MECCANO LTD

ARTICLE PUMMEL FOR 3½" GEAR WHEEL

JOB No. 97.

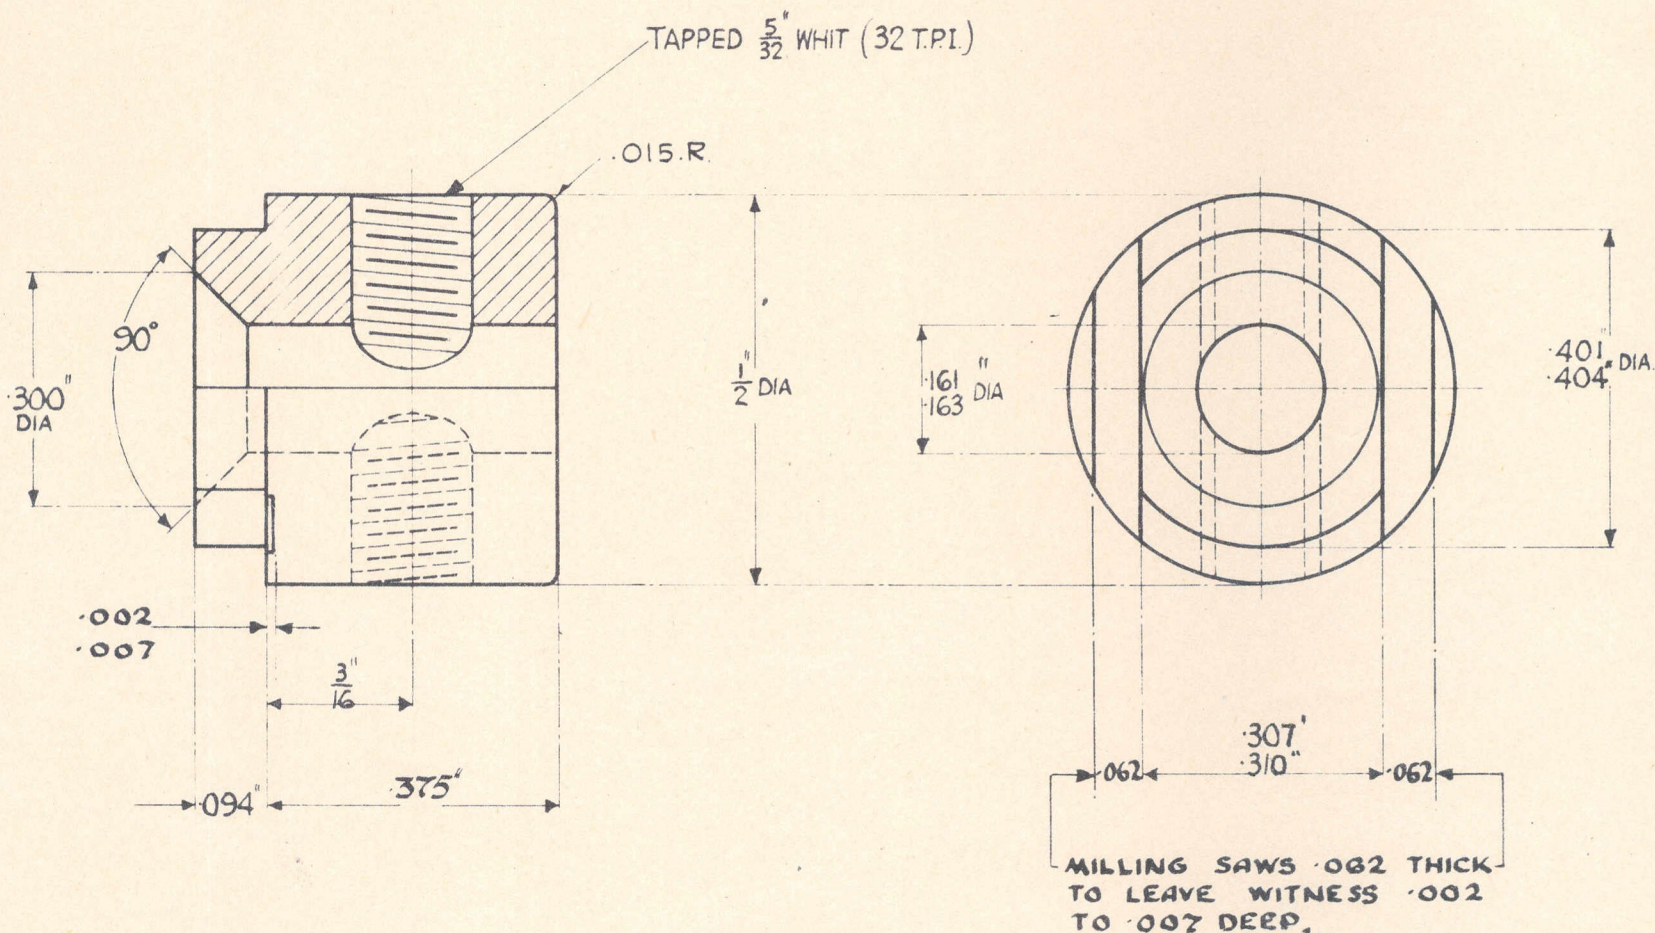
ISSUE	DESCRIPTION OF CHANGE	C.O. No	DATE	SIG.
8	DIMENSIONS .307/310 & 401/404 WERE 309/312 & 403/406	3747	15-10-53	K.R.
7	NOTE ON MILLING SAWS ADDED:	2916	20-3-50	K.R.
6	DIM. .375" WAS 3/8"	2729	9-9-49	J.W.
5	REDRAWN. DIM. 3/16" ADDED & LIMITS APPLIED.	1379	22-9-39	L.M.
MATERIAL $\frac{1}{2}$ " DIA SOFT BRASS ROD
